Application for Certification for the ABENGOA MOJAVE SOLAR POWER PLANT

Docket No. 09-AFC-5

ABENGOA MOJAVE SOLAR PROJECT APPLICANT'S COMMENTS ON STAFF ASSESSMENT

Soil & Water Graph 5 Water Use Per Project Per Gwhr

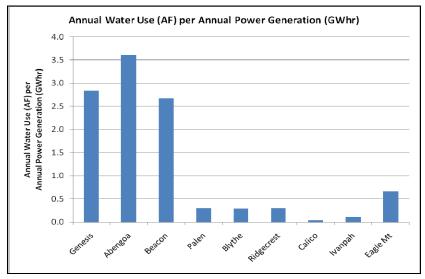
[Request: Please add SEGS to graph for comparison with actual operating plants.]
